TOWN OF ARLINGTON
DEPARTMENT OF PLANNING and
COMMUNITY DEVELOPMENT

MEMORANDUM

To: Zoning Board of Appeals
From: Jennifer Raitt, Director, Dept. of Planning and Community Development/kl
Date: 11/15/2021
RE: Docket 3676 – 16-18 Swan Place; Special Permit under Zoning Bylaw Section 6.1.10 (A)
(Location of Parking Spaces)

Below are aerial and street-view photos of the current building:

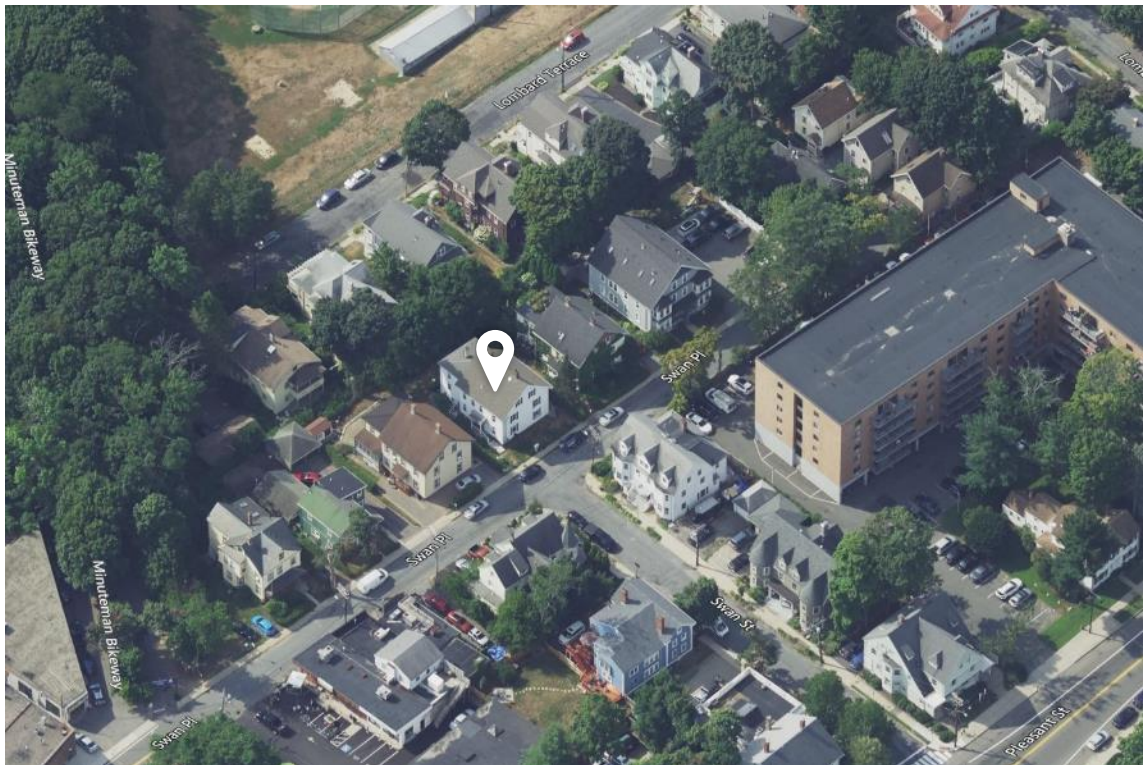
Furthermore, the existing entry stairs on each side of the structure project forward from the front façade, unlike the condition shown in the provide land surveys. The location of the stairs would require vehicles to park further back to provide sufficient space for residents to access the entries to the building. This would present a hazard to pedestrian safety.

Properties along Swan Place and Swan Street provide parking along the front or side yard setback, in driveways or in larger parking lots. An adjacent property has provided parking through one driveway with two curb cuts so residents can pull through the front yard to park. If the dimensions of the proposed parking at 16-18 Swan Place could reasonably accommodate a standard sized vehicle, the variation in parking provisions among abutting structures would provide an environment where parking in the front yard setback would not be detrimental to the character of the district. However, as noted above, the front yard setback is only 15 feet. Under the proposed conditions, a portion of a parked car would block the sidewalk.

The property at 16-18 Swan Place is set back 15 feet from the sidewalk, with small side yard setbacks on either side of the structure. The side yards are of insufficient size to provide off-street parking for residents of the structure. There is no ability to provide off-street parking anywhere on the property except within the front yard setback.

The Department of Planning and Community Development maintains under either of the proposed configurations, the potential barriers to the sidewalk and threat to pedestrian safety outweigh the benefit to the applicant of providing two off-street parking spaces. DPCD maintains that this proposal is not consistent with the Zoning Bylaw, nor does it meet the four variance criteria, and recommends that the Zoning Board of Appeals deny this application or work with the applicant to develop a revised parking proposal.
